Truck Equipment Service Co. response to Preliminary Evaluation  
[PE13-032]

8" CHANNEL W/.375 BASE  
END USE CODE  
PART NO.  
DWG. NO.  
SECTION NUMBER

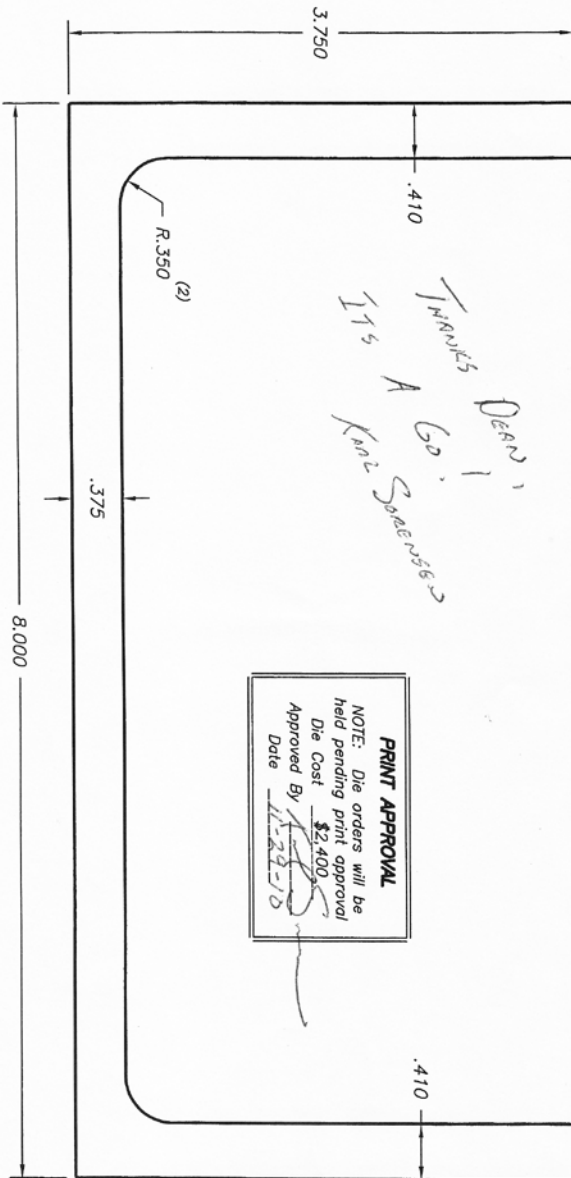
When the 8" channels showed signs of failing, we worked with our aluminum extrusion supplier (SAPA) to make a running engineering change to increase the thickness of the web on the 8" channel from .250" to .375".

We also added (1) extra 5/8" Huck bolt fastener to the attaching angle located on the front of the 8" channel going from (2) to (3) fasteners. We ran a FEA analysis to confirm our modification plans. I am including that analysis as a separate attachment.

The modifications done to the pickup plate assembly were done to (4) 8" alum channels that run from the front nose rail to the back structural beam. This channel is an aluminum extrusion. We ordered a new die to produce this channel with a .375" thick web. The original web was .250" thick.

We also went from (2) to (3) 5/8" Huck bolts to attach the 8" channel to the front nose rail.

- (a) This new revision of the channel was implemented into our new production on or around 03/17/11.
- (b) The channel 'web' was increased in thickness from .250" to .375". (1) extra 5/8" Huck bolt fastener was added to the front of each channel.
- (c) These changes were made in response to customer complaints, of cracks found during visual inspections.
- (d) The part number of the original 8" channel is [AY56561008]
- (e) The part number of the modified channel is the same, as this was done as a running engineering change, and both versions are interchangeable.
- (f) The original channel with the .250" web was withdrawn from production on or around 03/17/11. The remainder on hand was scrapped.
- (g) The modified AY56561008 was available for resale or repair on or around 03/17/11.
- (h) Both versions of the 8" channel are interchangeable.
